NOTICE OF MEETING

Planning and Environment Committee Meeting No. 4/13

Item		Page
1	CONFIRMATION OF MINUTES - Meeting held on 5 March 2013	1
2	6 GANORA STREET, GLADESVILLE. LOT 6 DP 27608. Local Development Application for alterations and first floor addition to dwelling. LDA2012/0426. <i>INTERVIEW 5.00PM</i>	7
3	20 BEATRICE STREET, NORTH RYDE. LOT 73, DP 36618. Local Development Application for a new two storey dwelling. LDA2012/0408. <i>INTERVIEW 5.05PM</i>	43
4	62 DARVALL ROAD EASTWOOD. LOT 11 DP 6247. Local Development Application for demolition of the existing dwelling and erection of an attached dual occupancy. LDA2011/380. <i>INTERVIEW 5.10PM</i>	86

Figure 2: Proposed shadow at 9:00am 21 June (no shadow cast on 7 Ganora Street)

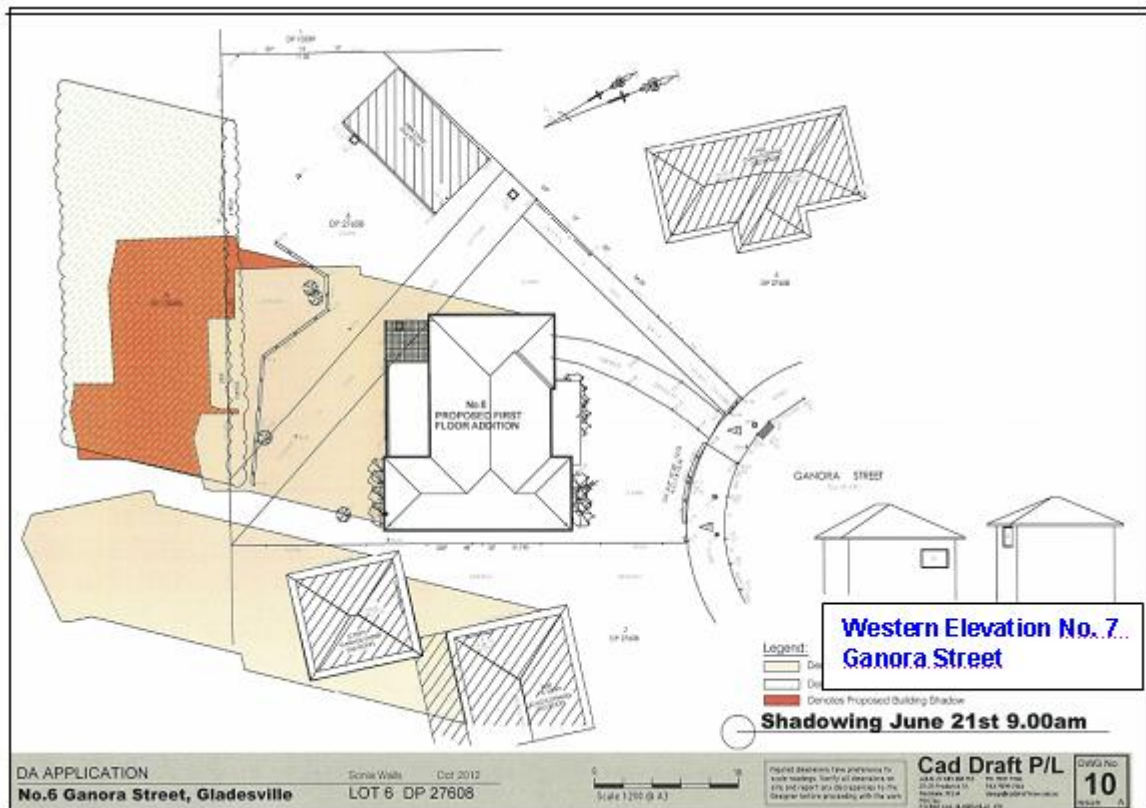
The shadow diagrams show that the shadows from the proposed first floor addition only begin to affect the neighbour's dwelling after 12 noon (on 21 June), and therefore it would receive more than the required 3 hours of sunlight to the north-facing living rooms in mid-winter.

Figure 5: Proposed Shadow on 7 Ganora Street Western Elevation windows only overshadowed on June 21st at 3pm, not affected by the proposal on 21st March, September and December at 3pm

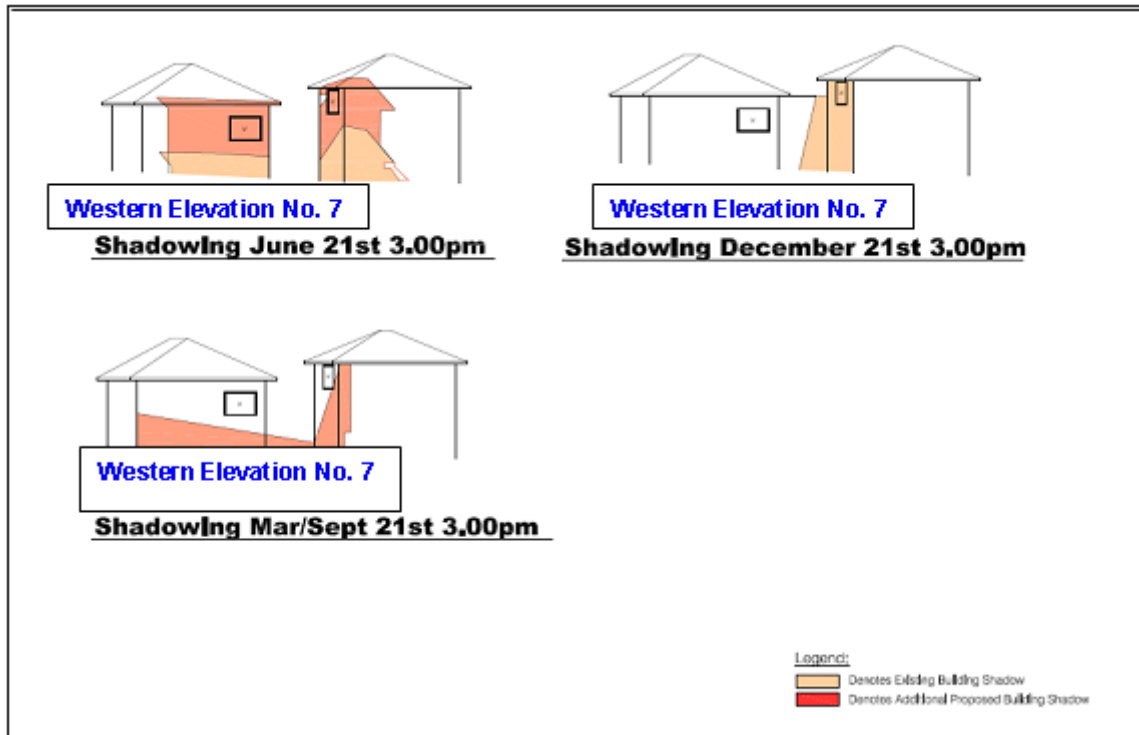
The applicant has also supplied elevational shadow diagrams showing the impact on the neighbour's property at other times of the year (ie March/September and December – see below). These show that at these other times of the year, the north-facing windows would be mostly unaffected before 3pm.

Figure 6: Northern Elevation showing the first floor side setback of 1500mm.

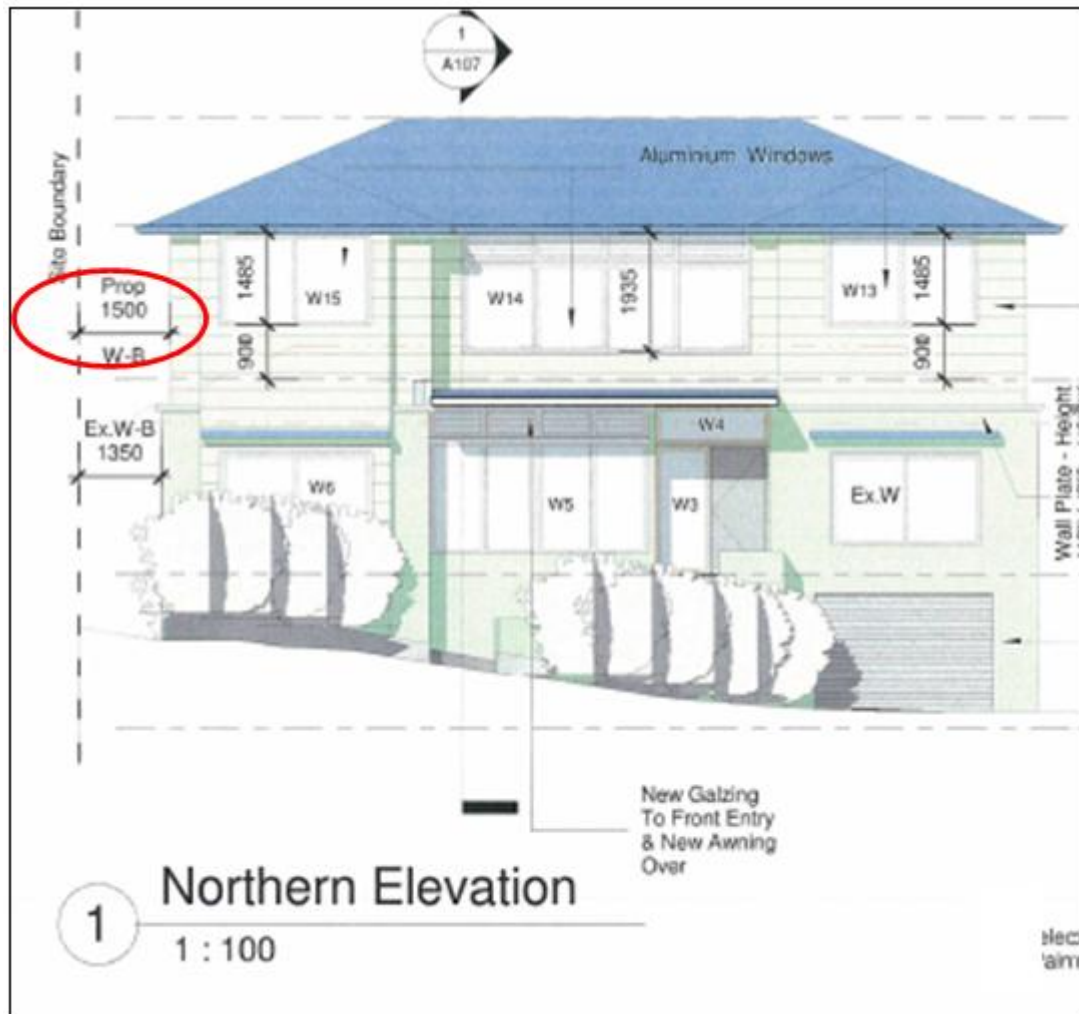
The first floor addition has a side setback of 1.5m from the eastern boundary adjoining 7 Ganora Street. The Northern Elevation below demonstrates compliance with Council's control (see below).

Figure 8: Southern elevation - Wall plate height ranges from 6.69m to maximum of 8.01m.

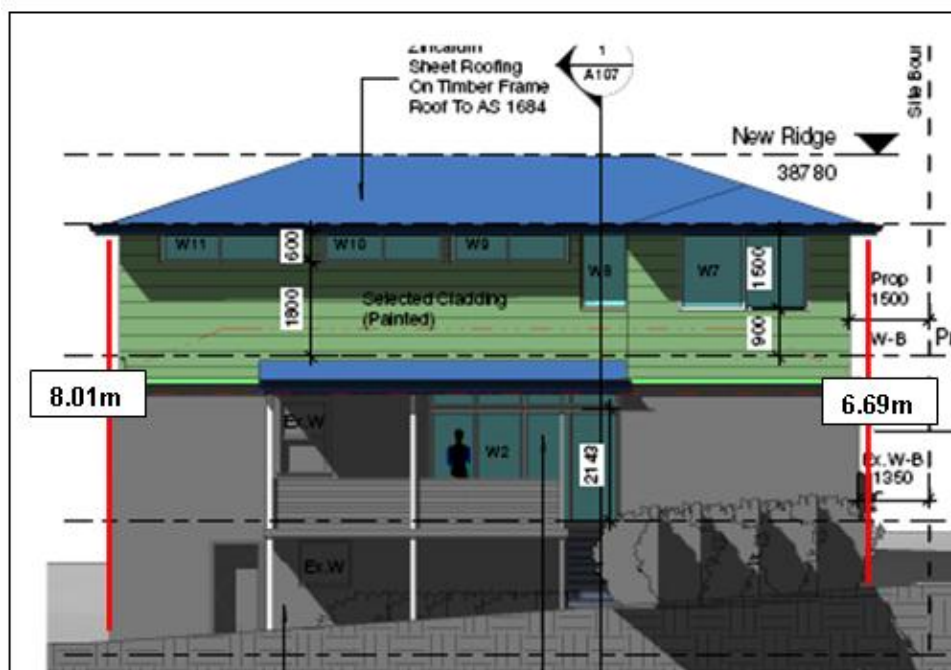
Maximum wall plate height (ceiling height) 7.5 metres or 8 metres for a roof which has a continuous parapet

The proposed maximum ceiling height is 8.18m. Due to the existing lower ground floor the maximum ceiling height is 680mm (9%) over Council's control for a portion of the dwelling on the southern and western elevations.

Figure 9: Site Plan – Three storey element and wall plate height distance to the western side neighbour ranges from approximately 5.07m to 13.30m and approximately 14.02m to the southern rear neighbour.

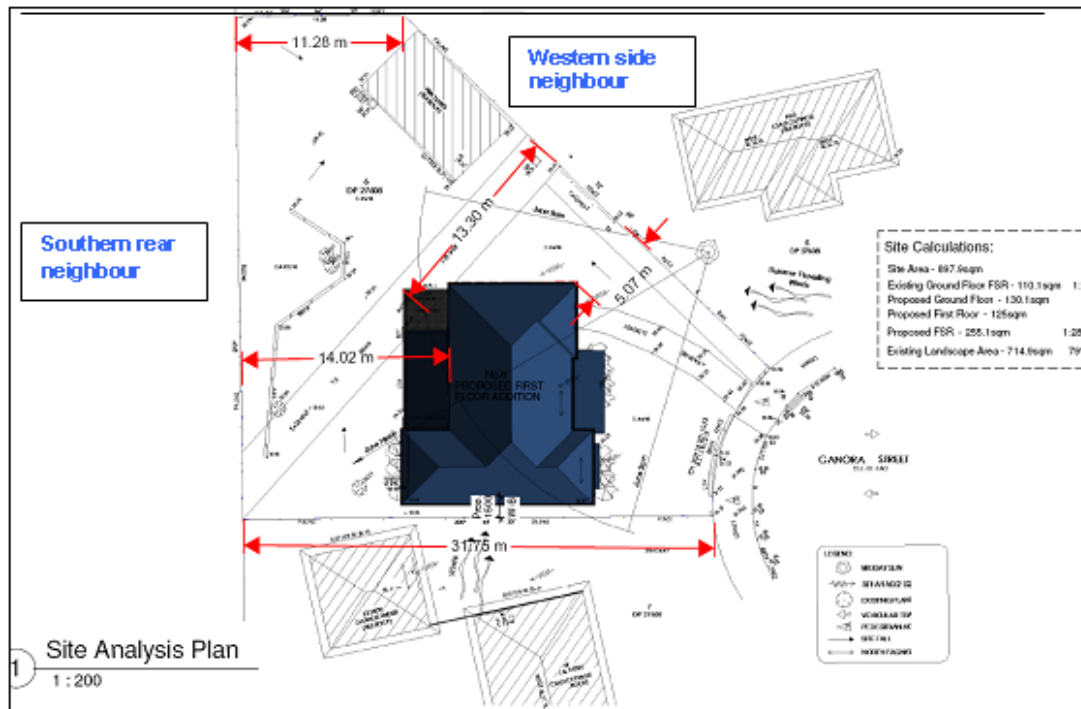
There are no adverse affects to the adjoining neighbours regarding privacy and overshadowing. The overall maximum height of the proposal is 9.5m and complies with Council's control and in this instance the maximum wall plate (ceiling height) is considered satisfactory.

Figure 9: *Direction of CBD Views from 22 Beatrice Street*

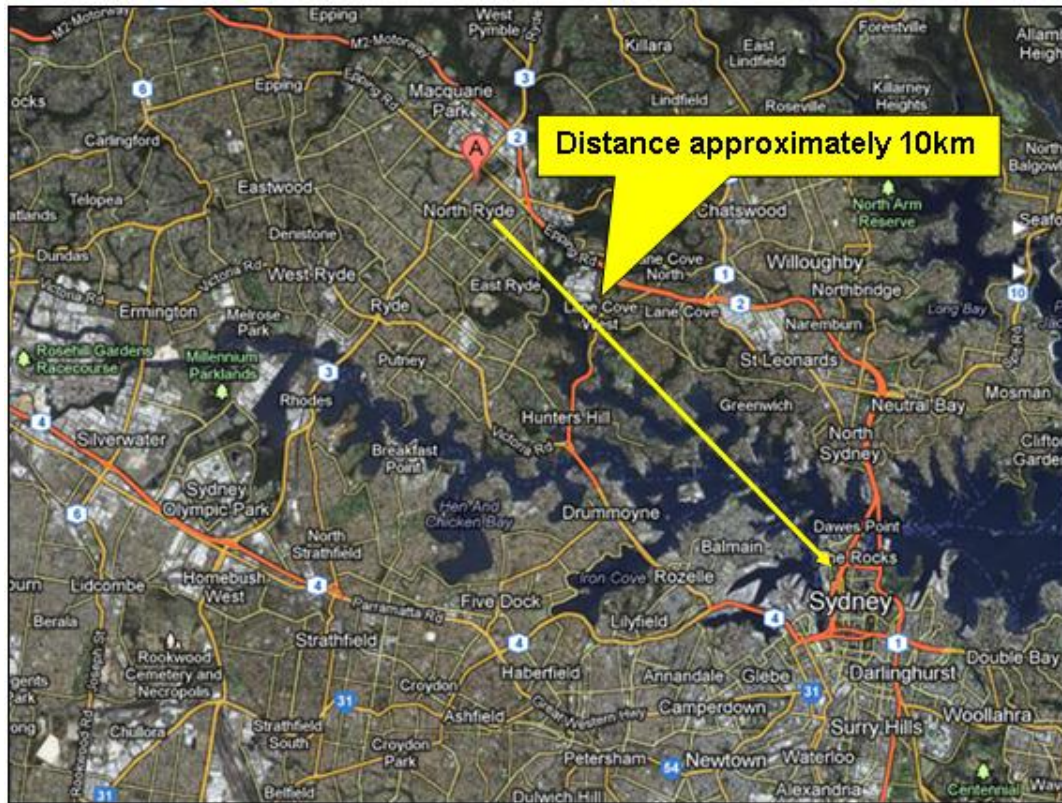
Officer's Comment: Distant views towards the east (the CBD skyline) and also North Sydney / St Leonards etc. are currently enjoyed by 22 Beatrice Street from the first floor windows on the southern-eastern side of the dwelling. Photographs taken from the first floor windows on the southern-eastern side of the dwelling indicate that the views from these windows will be lost by the construction of the proposed development. A height pole was used to estimate the ridge line of the proposed new dwelling. (see photos below)

Officer's Comment: An inspection of the objector's property (No 22 Beatrice Street) shows that the views are available from only the first floor level across the subject property (No 20 Beatrice). At the first floor level, these views are available to three of the bedrooms and a lounge room on the eastern side of the first floor level. The sill heights of these windows (approx 1.2m above the floor level) means that the views are only available from a standing position.

Figure 10: Window Openings on the North-Western Elevation

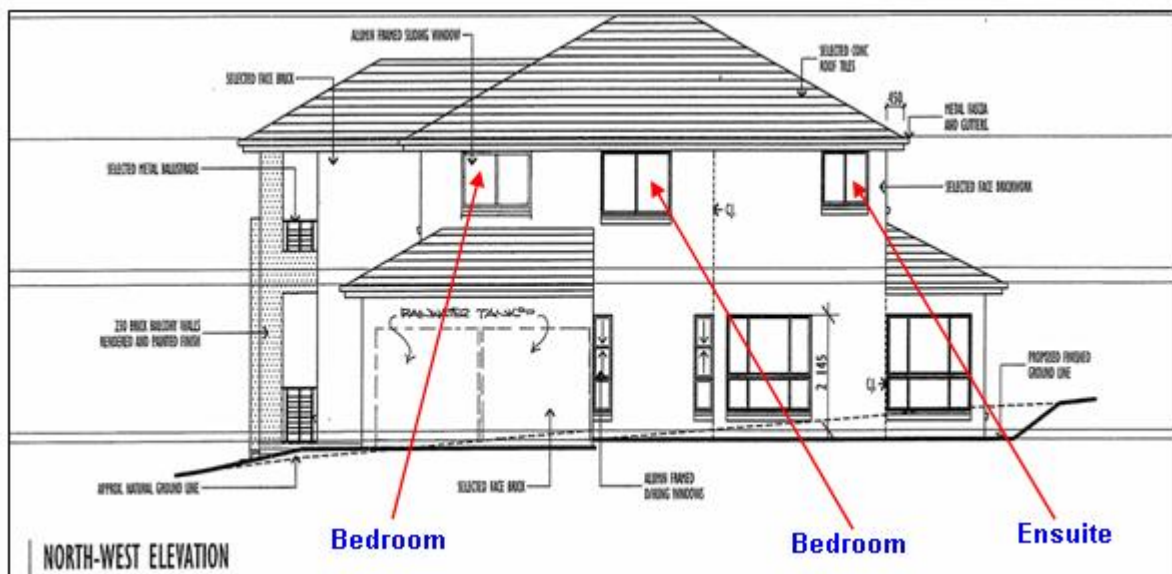
The dividing fence will restrict any loss of privacy from the ground floor level windows. There are three windows at first floor level on the north-western elevation of the proposed new dwelling facing the objector's property. Two of these windows are for bedrooms and the third is for an ensuite. Overlooking from first floor bedrooms does not cause privacy concerns as the occupancy hours of bedrooms are generally at night and when people are asleep. The ensuite window is also considered to have minimal impact. It should be noted that the north-western elevation is set back a minimum distance of 4.2m from the side boundary adjoining 22 Beatrice Street.

Figure 11:

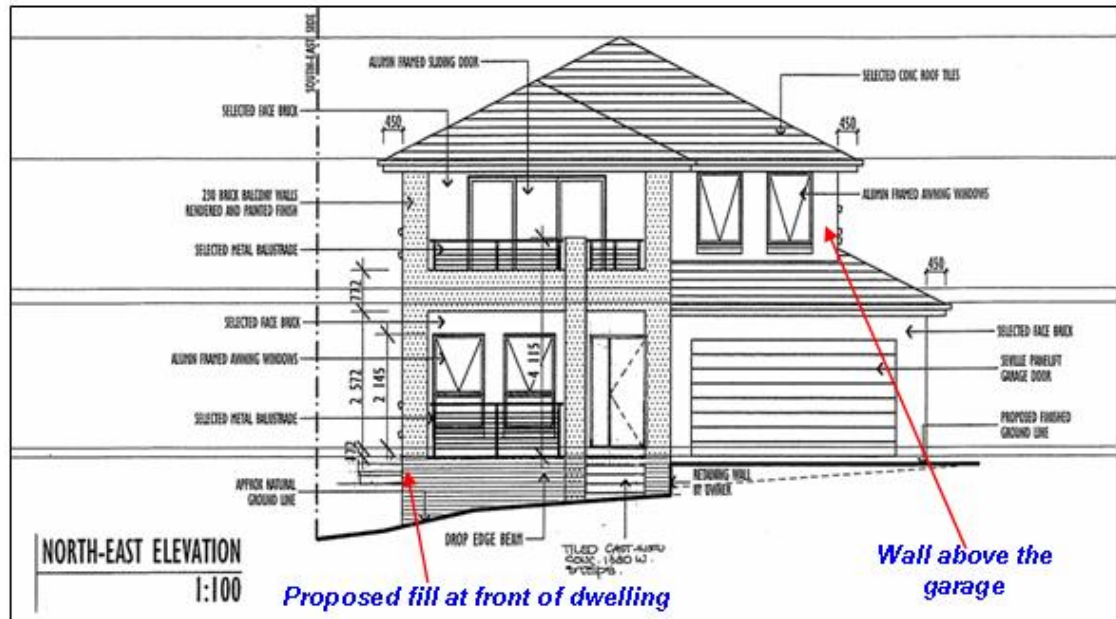
The proposed fill at the front corner on the south-eastern side is 1.09m. The increase in fill of 190mm is due to the topography of the site and has no impact on the overall development. This minor non-compliance is considered satisfactory. (see diagram - *proposed fill at front of property*)

The proposed wall above the garage is set back 1.5m. The wall is setback further in this situation for design purposes. The irregular front elevation is considered to add interest to the streetscape and considered satisfactory.
(*see diagram above – *wall above the garage*)
- **Daylight and Sunlight Access** – Council’s DCP 2010; Part 3.3 - Dwelling Houses & Dual Occupancy (attached) – Section 2.13.1 ‘Daylight and Sunlight Access’ states:
 - For neighbouring properties ensure that windows to north-facing living areas of neighbouring dwellings receive at least 3 hours of sunlight between 9am and 3pm on 21 June over a portion of their surface, where this can be reasonably maintained given the topography of the subject and neighbouring sites.

Figure 12: *North-west facing windows at No. 18 Beatrice Street*

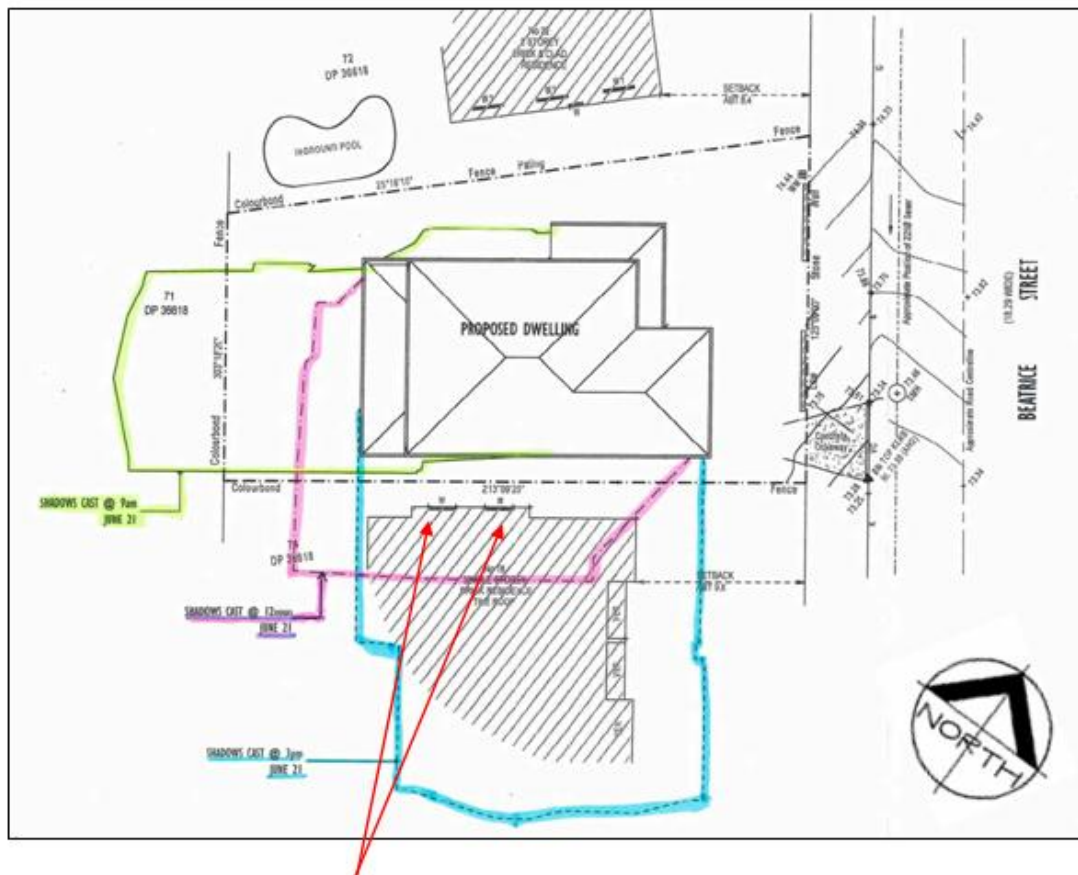
The submitted shadow diagrams indicate that the windows of the north-west facing living areas of the neighbouring dwelling at No.18 Beatrice Street will receive slightly less than 3 hours of sunlight between 9am and 3pm on June 21 over a portion of the surface. Given the orientation of the sites and that the proposed two storey dwelling is at a higher level than the adjoining single level dual occupancy, overshadowing in this situation cannot be avoided. It should be noted that no submissions have been received from the owners of 18 Beatrice Street in relation to the development as proposed.

Original Plans – North Elevation:

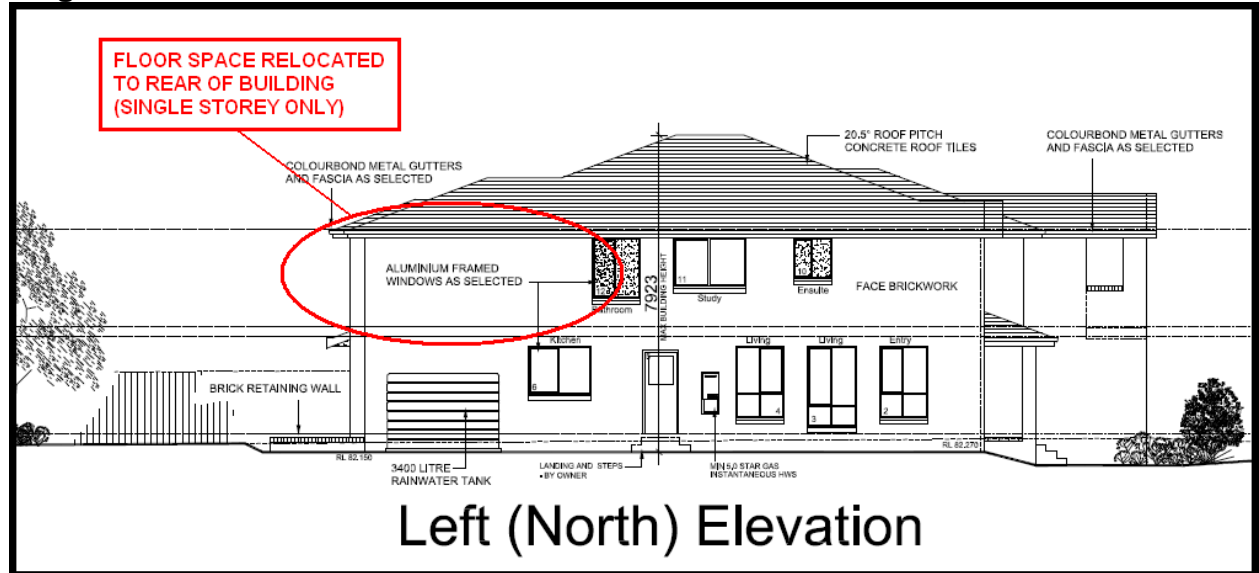
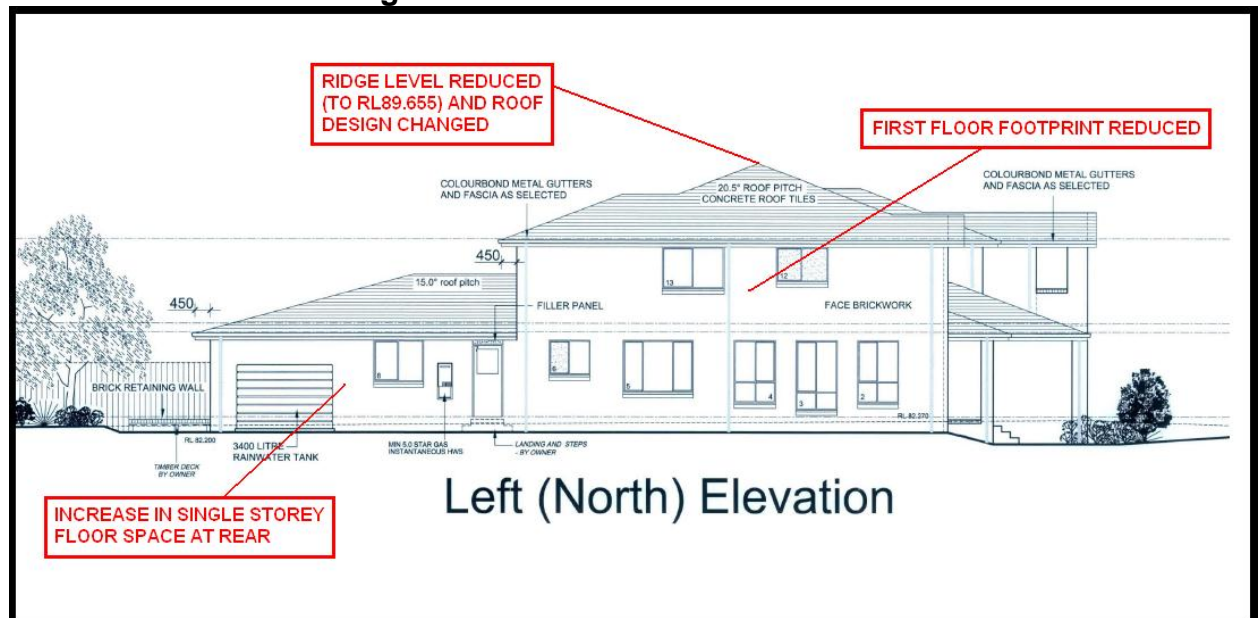
On 22 January 2013, the applicant submitted formal amended plans for this DA. The amendments included:

- Reduction in the first floor footprint (rear of proposed building is now single storey)
- Increase in floor space at ground floor level (towards the rear)
- Reduction in the maximum ridge height from RL89.843 to RL89.655 in the latest plans, as part of an overall change to the roof design.

The following drawings compare the current amendments to the original/previous proposal for this development.

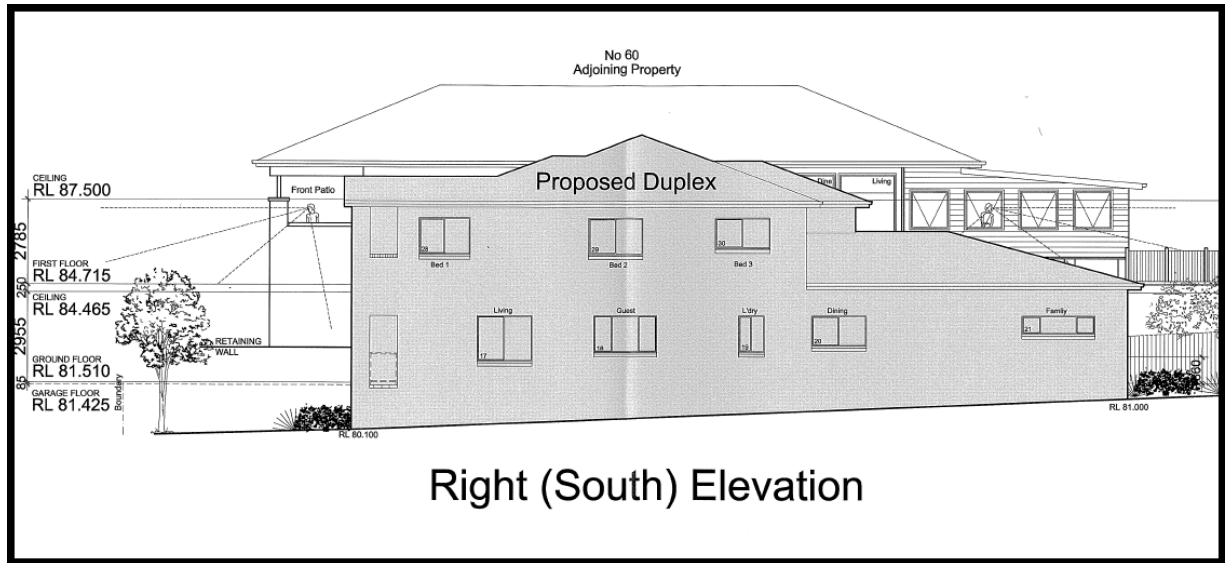
The following drawing is the South Elevation of the proposal with the neighbour's dwelling included (background), and it shows that the views out over the rear (single storey) portion of the dual occupancy are maintained for the rear part of the neighbour's dwelling (former rear verandah now enclosed to be a rumpus room, and also living room).

B. Privacy Impacts. *The neighbour at No 60 has requested that privacy screens be provided to the 3rd and 4th bedroom of Dwelling A and the 3rd bedroom of Dwelling B, to prevent direct viewing into their living areas.*

Comment: This request would appear to be excessive given that the rooms in question are bedrooms, which are not the primary living areas and are recognised as not causing significant privacy impacts as they are mostly used when people are asleep.
